WASHINGTON 1000

SUMMARY OF CONSULTANT'S COMMENTS ON FIRST SUBMISSION SHOP DRAWINGS

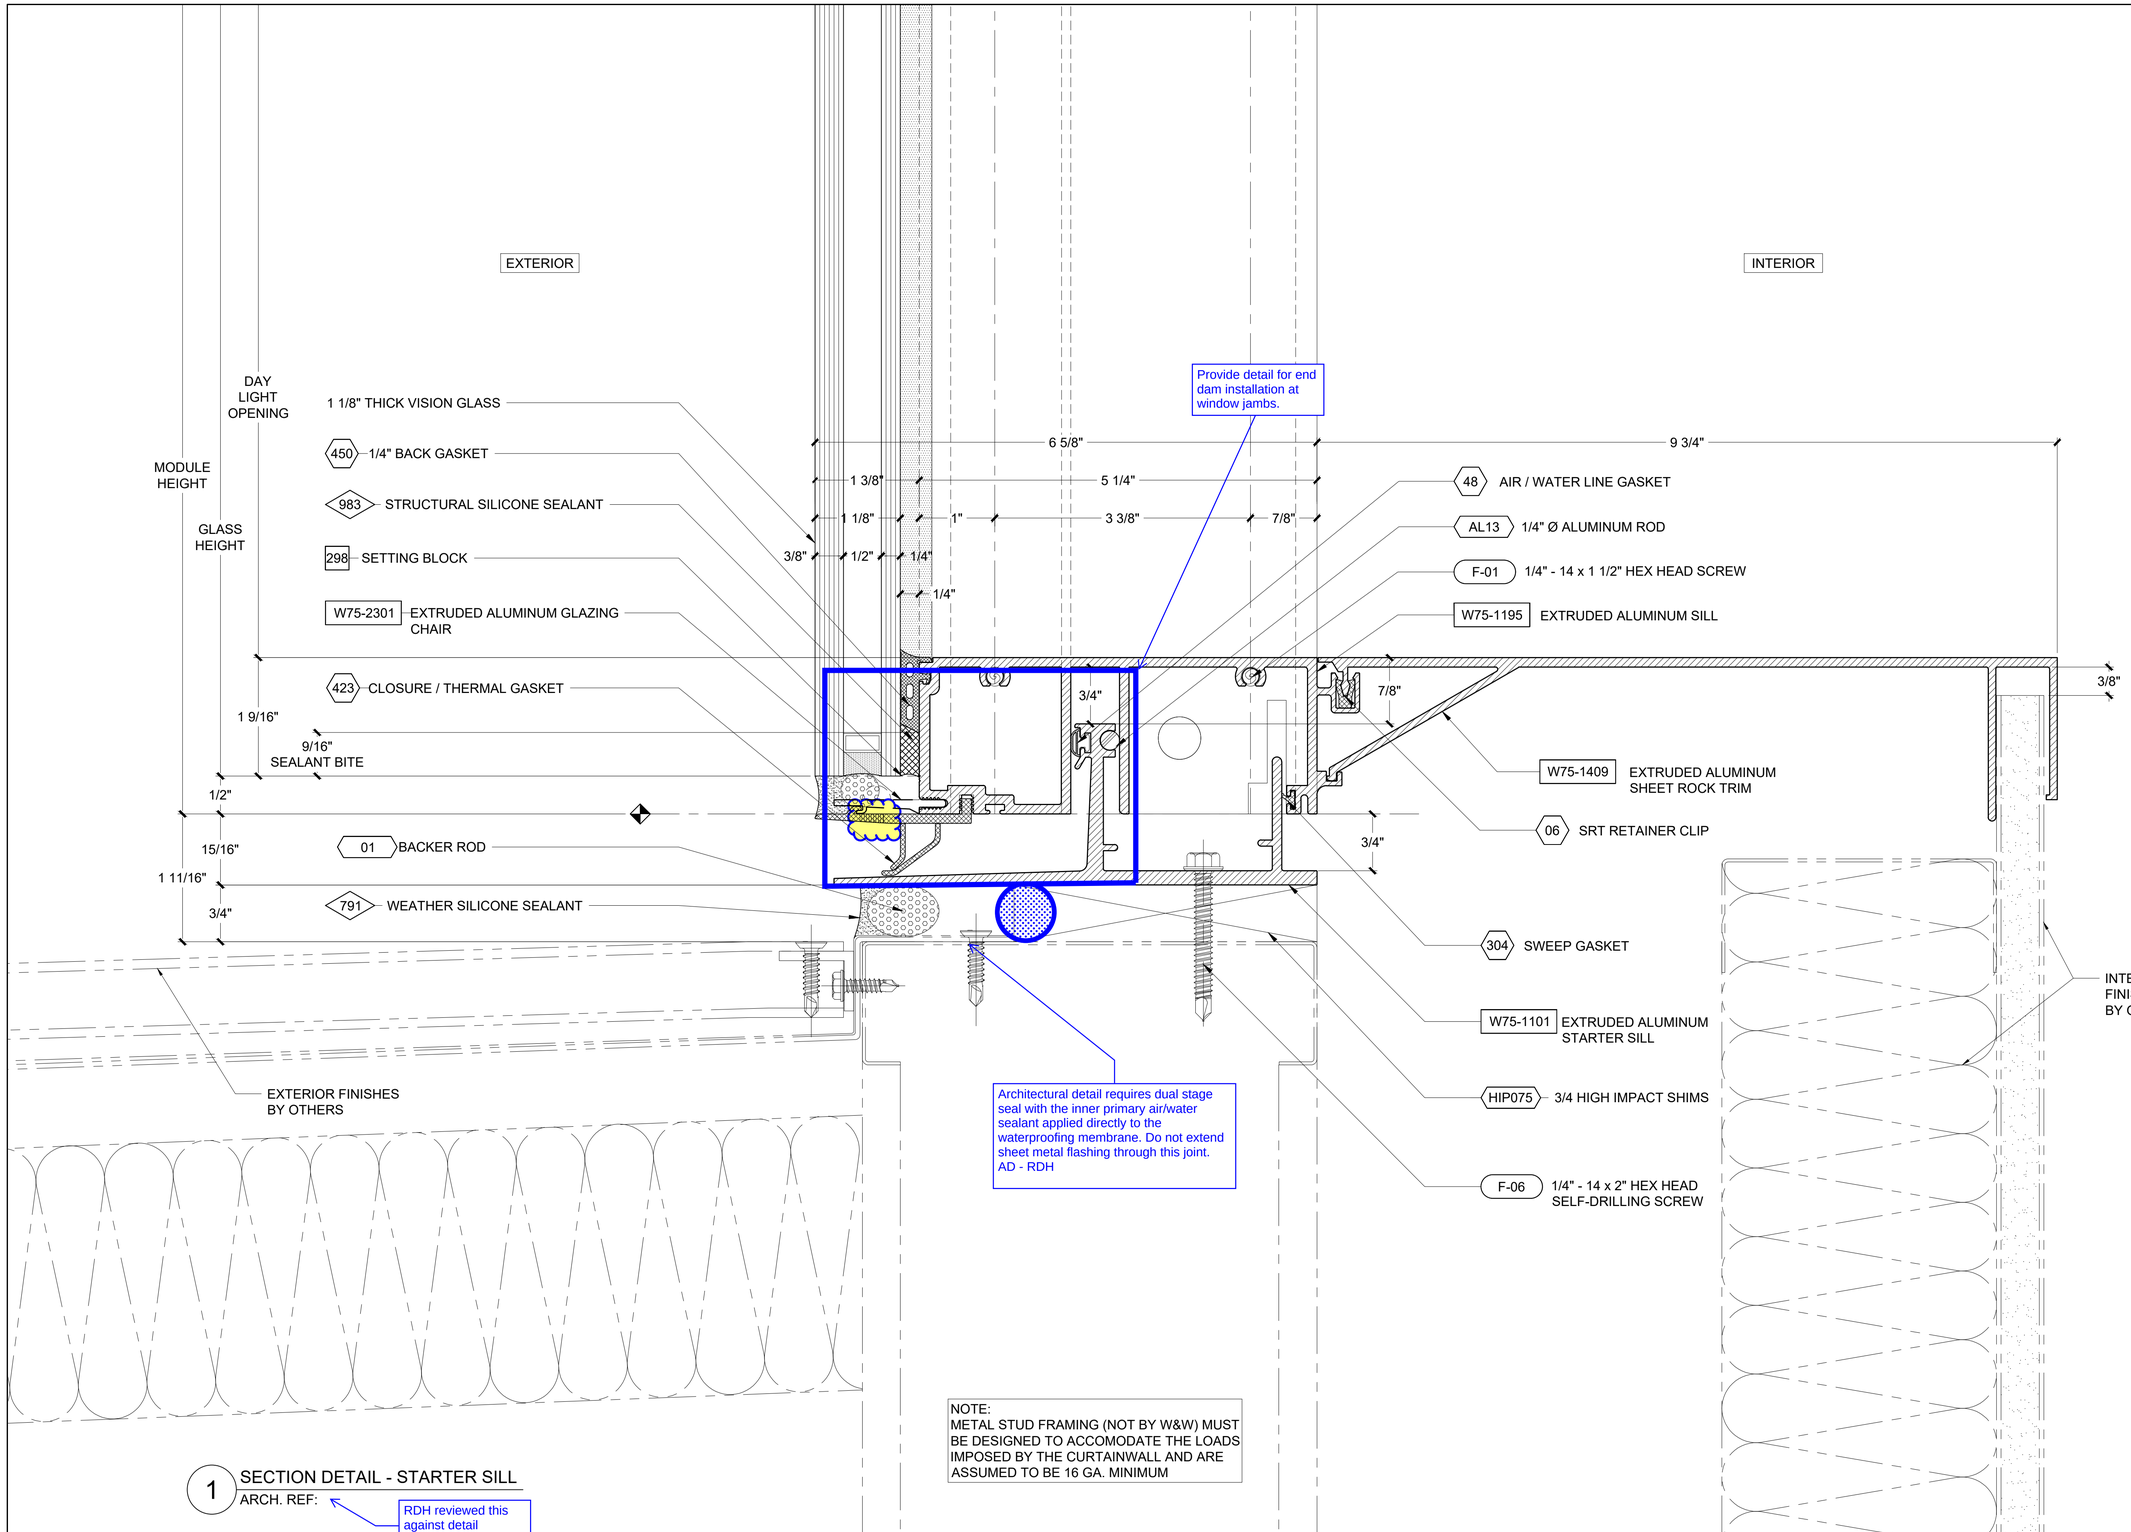
NOTE:
METAL STUD FRAMING (NOT BY W&W) MUST BE DESIGNED TO ACCOMODATE THE LOADS IMPOSED BY THE CURTAINWALL AND ARE ASSUMED TO BE 16 GA. MINIMUM

RDH reviewed this against detail 17/A431

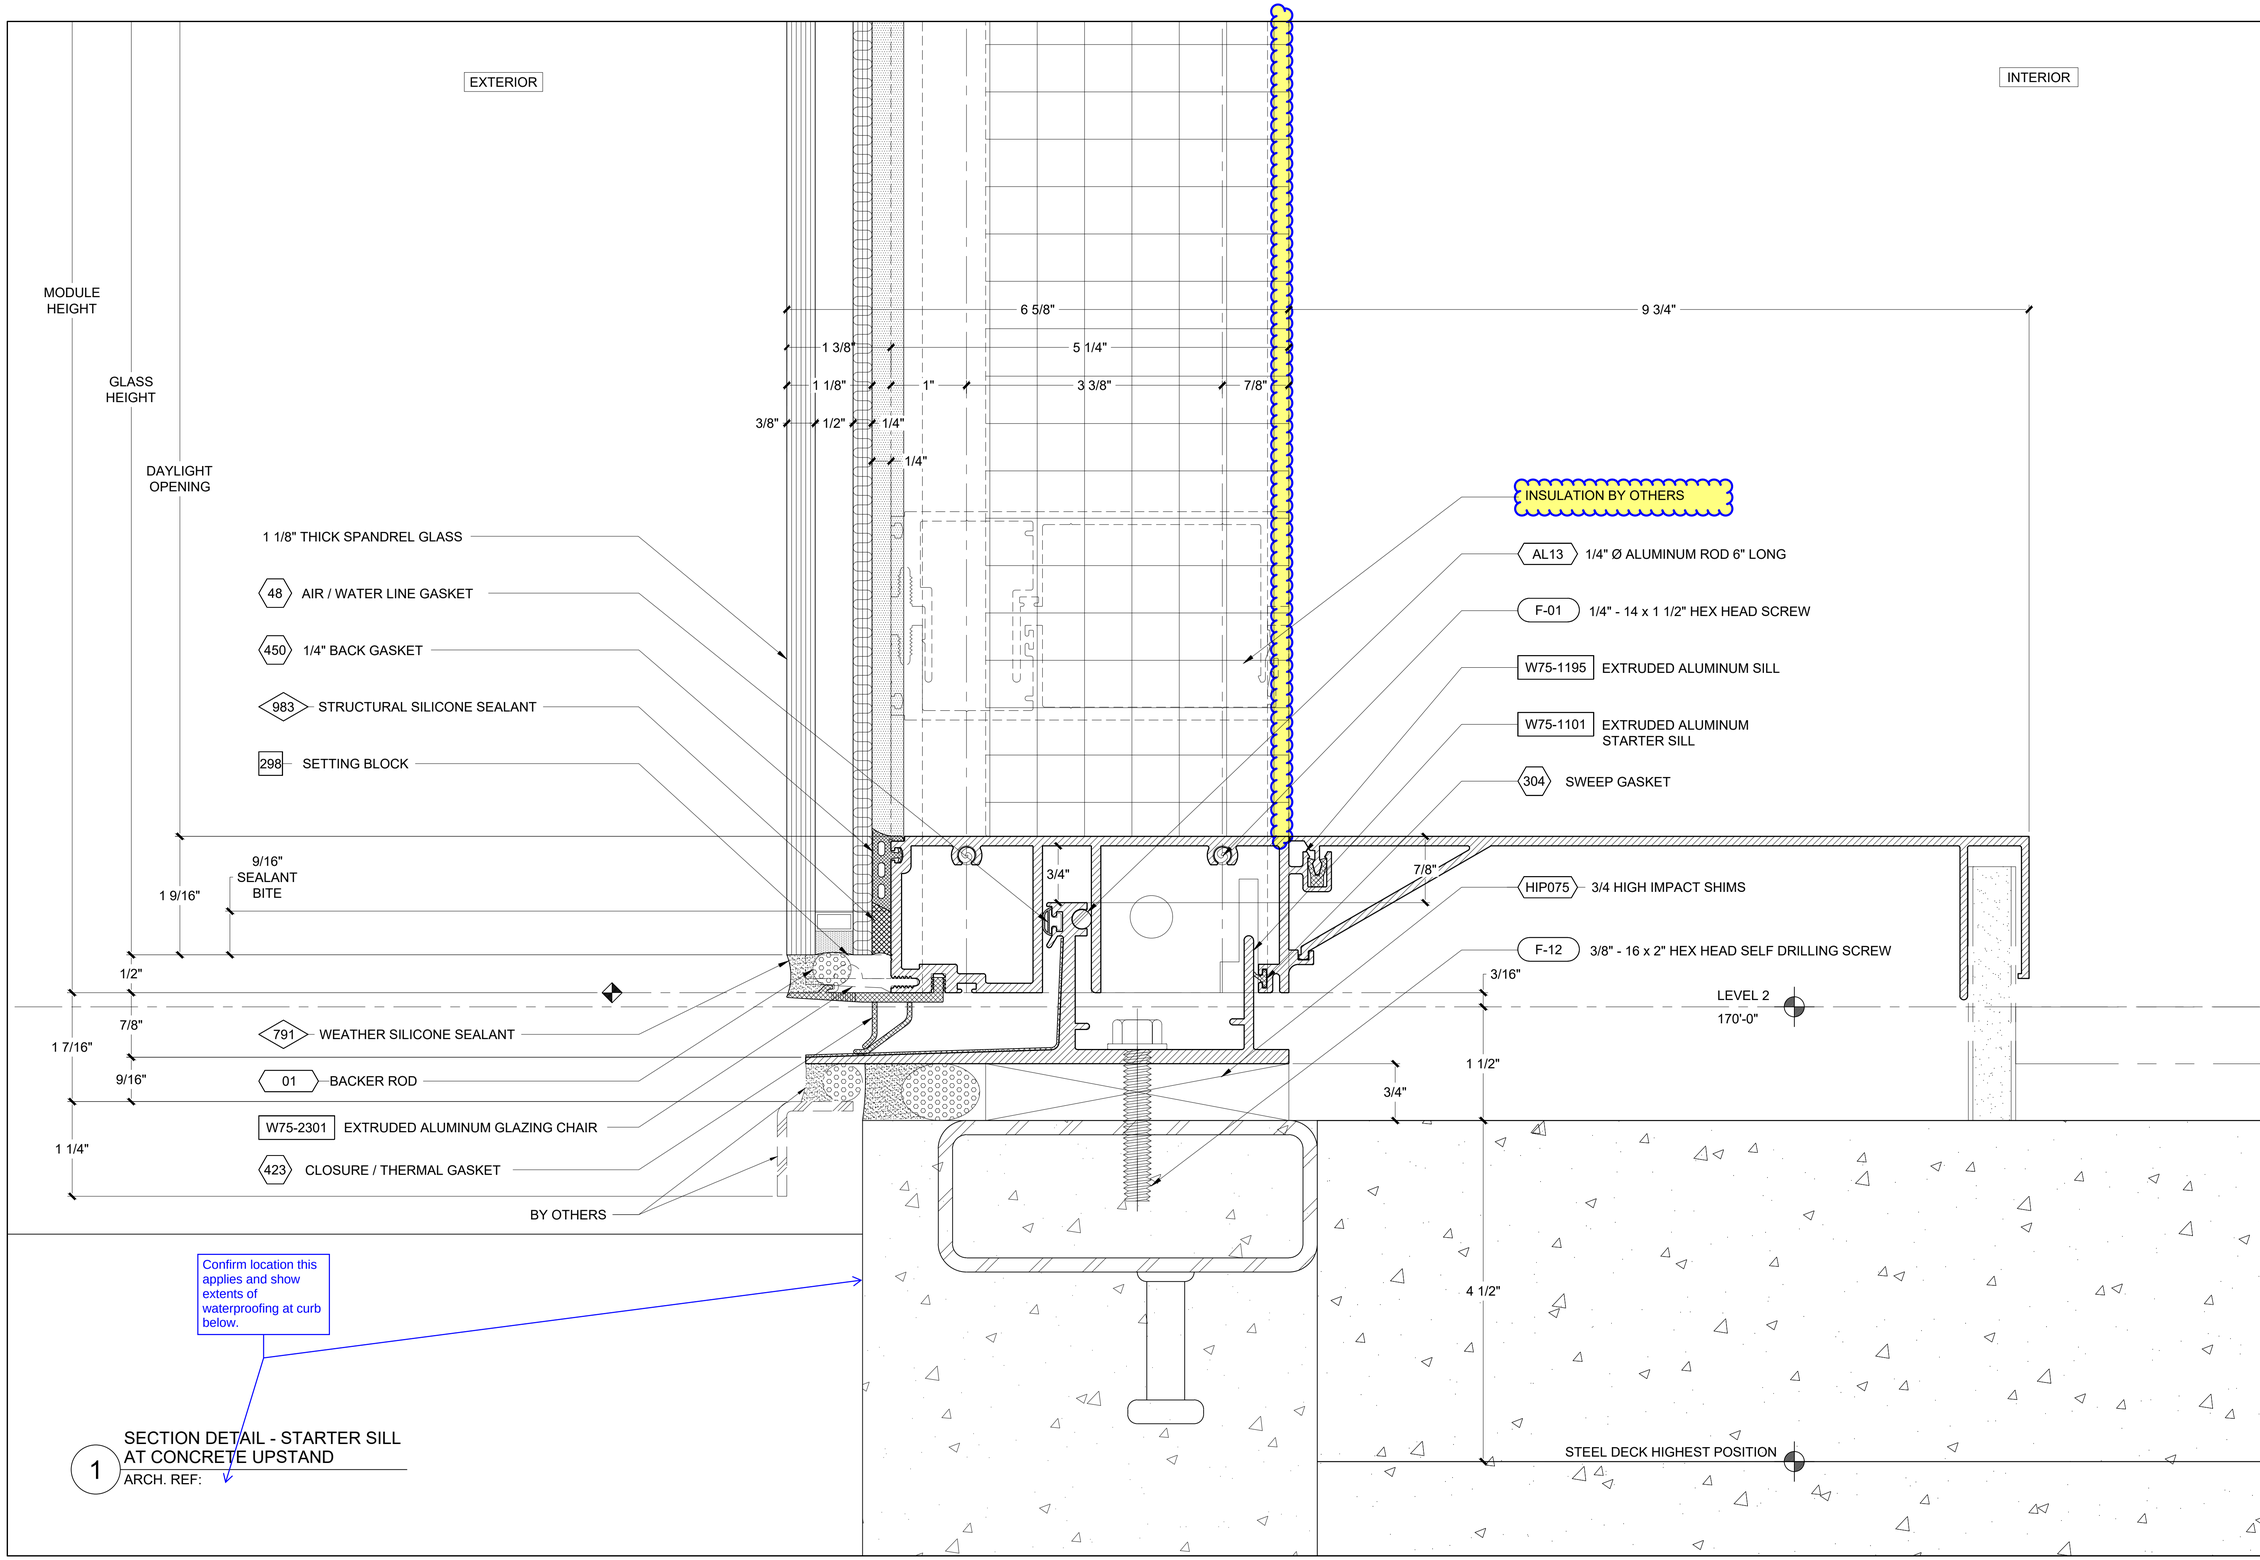
Confirm location this applies and show extents of waterproofing at curb below.
